C/ 00 SC P3/ 1 # 57 C/ 00 SC P3 L 5 # 2 Graber, Steffen Pepperl+Fuchs GmbH Graber, Steffen Pepperl+Fuchs GmbH Comment Type Ε Comment Status A F7 Comment Type Ε Comment Status A F7 . specifies additions to and appropriate modifications to add 10 Mb/s. (remove 'to' after physical layer (in Keywords section most of the words start with a capital letter, should be 'additions') uniform) SuggestedRemedy SuggestedRemedy . specifies additions and appropriate modifications to add 10 Mb/s. Physical Layer Response Response Status C Response Response Status C ACCEPT. Replace "specifies additions to and" with "specifies additions and" ACCEPT. Replace "physical layer" with "Physical Layer" as per the IEEE 802.3 Working Group editorial guidelines. C/ 00 SC P 3 L 4 C/ 00 SC 0 P 11 / 26 # 60 Graber, Steffen Pepperl+Fuchs GmbH Maguire, Valerie The Siemon Company Comment Type Comment Status R Comment Type Comment Status A F7 copper (in Keywords section most of the words start with a capital letter, should be uniform) It's recommended to flag the new frontmatter text with an editor's note so that this material SuggestedRemedy will be sure to be reviewed when the document goes out for Working Group rev

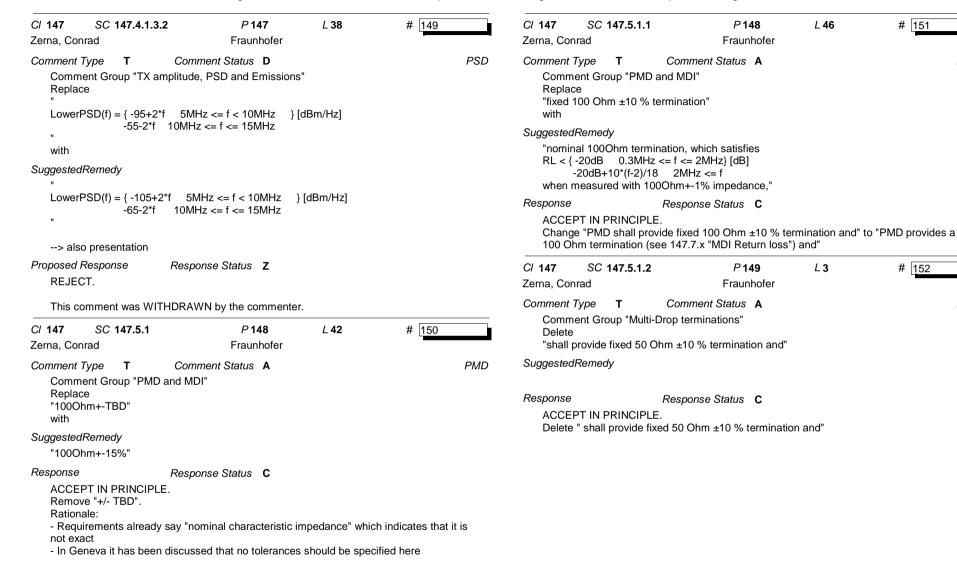
C/ 147 SC 147.2.3 P 139 L 2 # 107 C/ 147 SC 147.2.3 P 140 L 19 # 91 Huszák, Gergely Kone Xu, Davin Rockwell Automation Comment Type E Comment Status A Editorial Comment Type T Comment Status A F7 The term "the SSD symbol" does not harmonize with the rest of the clause rx data<2:0> is wrong, should be rx data<3:0> SuggestedRemedy SuggestedRemedy Change "the SSD symbol" to "an SSD" Change rx data<2:0> to rx data<3:0> Response Response Status C Response Response Status C ACCEPT ACCEPT. Change "the SSD symbol" to "an SSD" Change "rx data<2:0>" to "rx data<3:0>" Note: this is editor's own comment, rooted in a discussion directly following D1.0 resolution Cl 147 SC 147.2.3 P 140 L 27 # 92 C/ 147 SC 147.2.3 P 139 L 12 # 87 Xu. Davin Rockwell Automation Rockwell Automation Xu, Dayin Comment Type T Comment Status A F7 Comment Type E Comment Status A Editorial rx data<2:0> is wrong, should be rx data<3:0> SILENCE is also defined in 147.2.2.1, should be included here SuggestedRemedy SuggestedRemedy Change rx_data<2:0> to rx_data<3:0> Change "For the definition of pcs reset, SYNC, ." to "For the definition of pcs reset, Response Response Status C SILENCE, SYNC, ." ACCEPT. Response Response Status C Change "rx data<2:0>" to "rx data<3:0>" ACCEPT IN PRINCIPLE. - Change "For the definition of pcs reset, SYNC" to "For the definition of pcs reset, C/ 147 SC 147.2.3.1 P 139 L 32 SILENCE, SYNC" Xu, Davin Rockwell Automation - Change "147.2.2.1 and following." to "147.2.2.2." Note the change of 1 to 2 Comment Type E Comment Status A **PCS** SILENCE has already been defined in 147.2.2.1 C/ 147 SC 147.2.3 P 140 L 19 # 90 SuggestedRemedy Xu, Dayin Rockwell Automation Delete "SILENCE" variable definition. Comment Type T Comment Status A Editorial Response Response Status C Rxn-4 is not consistant with "RX" variable definition ACCEPT IN PRINCIPLE. SuggestedRemedy Already dealt with by #87 Change Rxn-4 to RXn-4; search other Rxs in Figure 147-5 and replace them with RXs Response Response Status C ACCEPT IN PRINCIPLE.

Change <all> case sensitive pattern "Rxn" to "RXn" to keep consistentcy of the clause.

Note: at the time of comment resolution 8 occurrences were found
